Access Compliance Report

Public Rights-of-Way

(Curb Ramps)

Intersection ID: 47297	Main Street: LELA_AV	Cross Street: HURSTON_CR	Location: SW
ADA ID: A25E25651CDA	Ramp Type: BlendTrans1	Initial Pass/Fail: Pass	Overall Compliance: No
Severity Score: 15			
Codes/Mitigation Info/Possible Solution		Field Measurements/Component Compliance

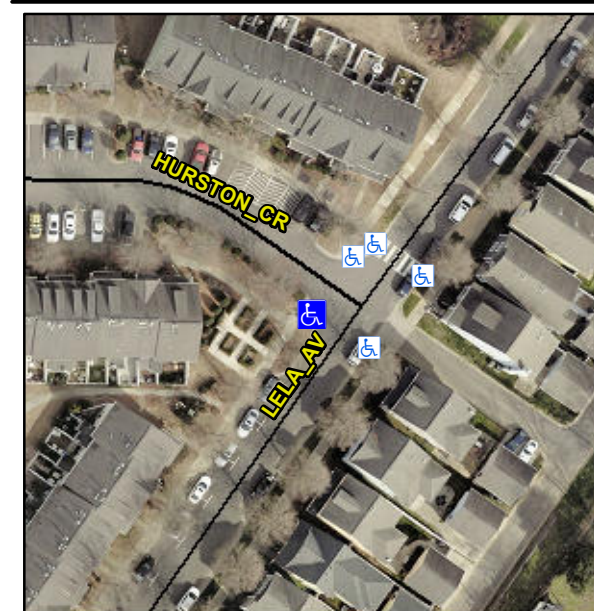
R304.2.2-Perp, R304.3.2-Para, R305.1.4, R305.2, R302.7, R302.7.2, R304.5.4

Compliance	Description	Data	Compliance	Description	Data
N/A	Ramp Length (in)	53.0	Yes	BlendTrans Slope (%)	2.7
Yes	Ramp Width (in)	49.5	Yes	BlendTrans XSlope (%)	0.5
N/A	Flare Type LT	Sloped	N/A	Flare Type RT	Sloped
N/A	Flare Slope LT (%)	5.1	N/A	Flare Slope RT (%)	3.9
N/A	Flare Traversable LT?	No	N/A	Flare Traversable RT?	No
Yes	Landing Length (in)	55.0	Yes	DWS Provided?	Yes
Yes	Landing Width (in)	51.0	Yes	DWS Contrast?	Yes
No	Landing Slope (%)	2.8	Yes	DWS Length (in)	24.0
Yes	Landing X Slope (%)	0.3	No	DWS Full Width?	No
N/A	Landing Curb? (Y/N)	No	No	DWS Offset (in)	4.0
N/A	Shared Landing?	No			
No	Gutter Ponding?	Yes	No	Gutter Slope (%)	6.4
No	Gutter Lip Ht (in)	0.5	Yes	Gutter X Slope (%)	0.1
N/A	Painted X Walk1?	No	N/A	Painted X Walk2?	No
	X Walk 1 Direction	To SE		X Walk 2 Direction	To NE
	X Walk 1 Width (in)	N/A		X Walk 2 Width (in)	N/A
	X Walk 1 Slope (%)	1.4		X Walk 2 Slope (%)	1.2
	X Walk 1 X Slope (%)	0.6		X Walk 2 X Slope (%)	0.5

N/A	Ramp inside XWalk1?	N/A	N/A	Ramp inside XWalk2?	N/A
	Road Slope (%)	2.6		Clear Space?	Yes
	Road X Slope (%)	0.4	N/A	Clear Space to XWalk (in)	N/A
Yes	Any Obstructions?	No	Yes	Storm Grate/Utility Hazard?	No
	Obstruction Type			Storm Grate/Utility Type	
		N/A			N/A
			Yes	Surface Condition? (G/P)	Good
			Yes	Curb Slope (%)	4.8

Remove & Replace Curb Ramp With Two New Directional Ramps or Equivalent. Remove & Replace Gutter.
